NEW RESIDENCE

1385 HILLSIDE CIRCLE, (LOT 3) BURLINGAME, CA
A.P.N.: 000-000-000

NEW RESIDENCE
1385 HILLSIDE CIRCLE LOT 3
BURLINGAME, C.A.
A.P.N.: 000-000-000

Showing portion of driveway recommended to be retained until the landscape phase of the project.

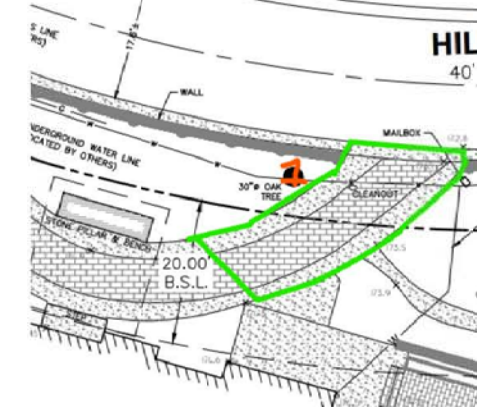
Impacts/Recommendations:
Oak tree #1 is to be retained. The tree is adjacent to an existing driveway. It is recommended to temporarily retain the existing driveway near this tree when underneath the dripline of the tree during the building phase of the project. Temporarily retaining the driveway will act as a tree protection measure and will help to increase staging and access to the site, as removing the driveway at the beginning of the project would make for a larger tree protection zone needed with the fencing being located at the tree's drip line. The existing grade within the tree's dripline is recommended to be retained as is where possible. No grading or excavation is recommended to take place within 10' from this tree (6x diameter) except for the removal of the driveway. At the end of the project, when it is time to demolish the existing driveway near this tree, the Project Arborist is

recommended to be on-site to document and witness the removal of the driveway. A jackhammer is recommended to be used when working within the tree's drip line to break the concrete material into hand manageable-sized pieces. Once broken down the driveway material is recommended to be removed by hand. Exposed roots during the process are recommended to be wrapped in layers of wetted-down burlap to avoid root desiccation. The existing driveway area is recommended to be filled back in once the driveway has been removed so that no roots are exposed to the elements. When backfilling the soil in this area, the area is also to be irrigated. The proposed driveway is further from the tree than the existing driveway and outside of the 10' range and is not expected to have impacts on the tree. The tree is recommended to be deep water fertilized with Nutriroot once the work near the tree has taken place as a mitigation measure for any minor impacts that may take place.

SITE DEMOLITION PLAN
SCALE: 3/32"=1'-0"

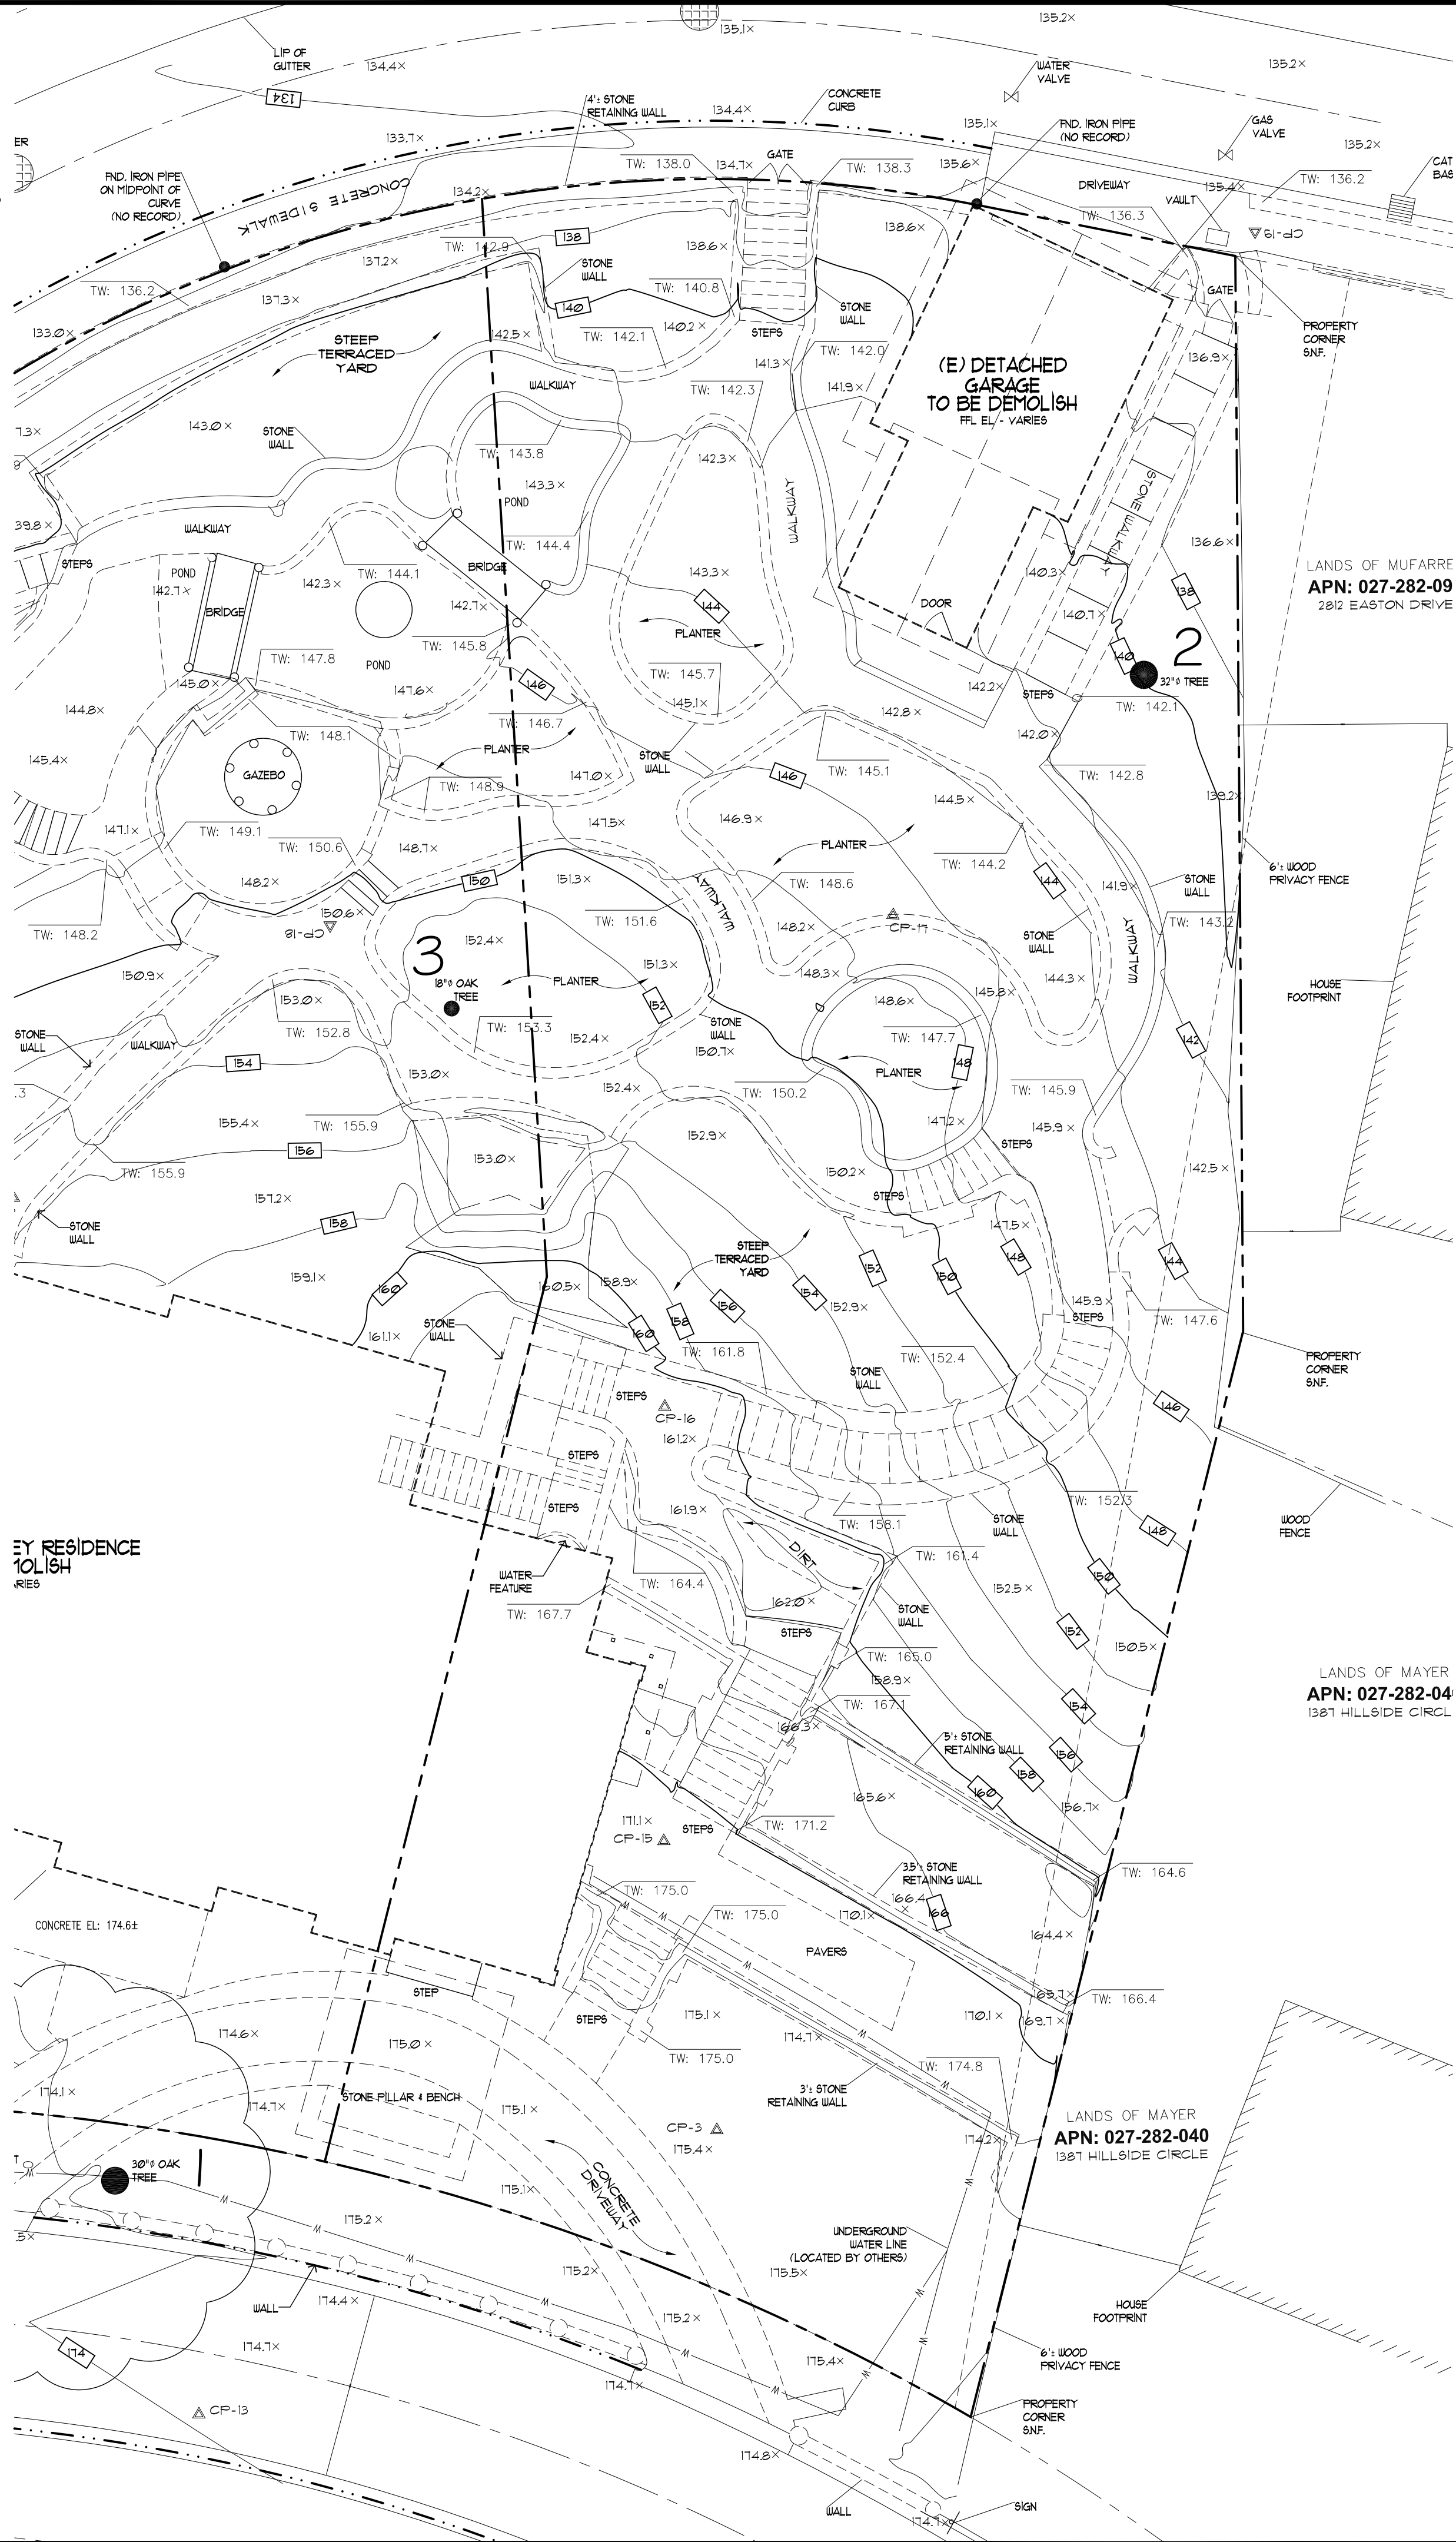
ENSURE THAT TREE PROTECTION SPECIFICATIONS ARE SHOWN GRAPHICALLY ON SITE PLANS FOR CONTRACTOR TO FOLLOW, AS FOLLOWS:

LOCATION OF ALL TREE PROTECTION MEASURES INCLUDING BUT NOT LIMITED TO FENCING, TRUNK WRAP, ROOT BUFFER, ARE TO BE GRAPHICALLY SHOWN ON DEMO PLAN A2 SO THAT CONTRACTOR CAN EASILY INSTALL AND EXECUTE THE TREE PROTECTION MEASURES.

LOCATIONS OF HAND DIGGING AND LOCATIONS OF WORK TO BE UNDER PROJECT ARBORIST SUPERVISION ARE TO BE GRAPHICALLY SHOWN ON THE RELEVANT SITE PLAN SO THAT CONTRACTOR(S) CAN EASILY UNDERSTAND AND EXECUTE THE SPECIFICATIONS. WORK WITH THE PROJECT ARBORIST TO PRODUCE ACCURATE INFORMATION ON THE RELEVANT SITE PLAN. SOME OF THE INFORMATION WILL BE ON THE A SHEETS AND SOME ON THE L SHEETS.

ARBORIST REPORT RECOMMENDS:
RETAINING SOME OF THE DRIVEWAY NEAR TREE 1 AND BREAKING IT DOWN BY HAND LATER IN THE PROJECT. PUT THIS ON DEMO PLAN A2 SO CONTRACTOR CAN FOLLOW IT.
CHANGING THE PATHWAY NEAR TREE 10 TO AVOID ROOT LOSS/DAMAGE. WHERE IS TREE 10? HAS THE PATHWAY BEEN CHANGED?

ARBORIST REPORT IS BASED ON REVIEWING L PLANS DATED JAN 2024, LOT 1 A PLANS DATED 10-26-22, LOT 2 A PLANS DATED 10-26-21 AND LOT 3 A PLANS DATED 10-26-21. NO CIVIL PLANS REVIEWED. NOTE THAT THE CONTENT OF CIVIL PLANS MAY NECESSITATE A CHANGE IN THE ARBORIST RECOMMENDATIONS.

INDICATE THAT AT LEAST 3 SINGLE-TRUNKED LANDSCAPE TREES WILL BE PRESENT ON EACH LOT, AS NOTED BELOW.
PER CHAPTER 11.06, THIS PROJECT REQUIRES 3 SINGLE-TRUNKED LANDSCAPE TREES FOR LOT 3.
TREES MAY BE EXISTING OR NEW.
REQUIRED TREES MAY NOT BE FRUIT OR NUT TREES, PALMS, ITALIAN CYPRESS OR JAPANESE MAPLE.
REQUIRED TREES MUST HAVE A MATURE HEIGHT OF OVER 15 FEET.
ALL REQUIRED TREES MUST BE IN GOOD CONDITION AT THE FINAL ARBORIST INSPECTION.
STREET TREES DO NOT COUNT TOWARDS THE REQUIRED TOTAL.

PROVIDE THE BOTANICAL NAME (GENUS AND SPECIES) AND LOCATION OF THE REQUIRED LANDSCAPE TREES, AND WHETHER THEY ARE EXISTING OR NEW, FOR EACH LOT.
